## Product Change Notice (PCN)

PCN Number: **PCN-0451148R-01**

Product(s) Affected: PJ-037A

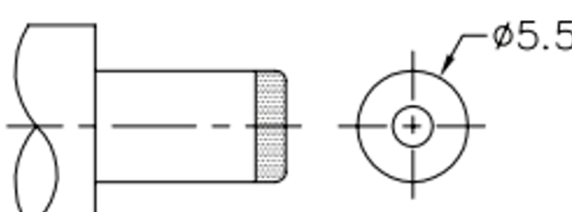
Description of Change: mechanical differences as shown below:

MATERIAL	PLATING
center pin	copper	nickel
terminal 1	brass	tin
terminal 2	copper alloy	tin
plastic	PBT

DESCRIPTION	MATERIAL	PLATING/COLOR
center pin	copper alloy	nickel
terminal 1	brass t=0.3 mm	nickel-silver
terminal 2	phosphor bronze t=0.3 mm	nickel-silver
housing	PBT (UL94V-0)	black
cover	PBT (UL94V-0)	black

**MATING PLUG**  
Jack Insertion Depth: **9.0 mm**

**MATING PLUG**  
Jack Insertion Depth: **9.8 mm**

Insertion/extraction force adjusted to 0.3 ~ 2.0 kg
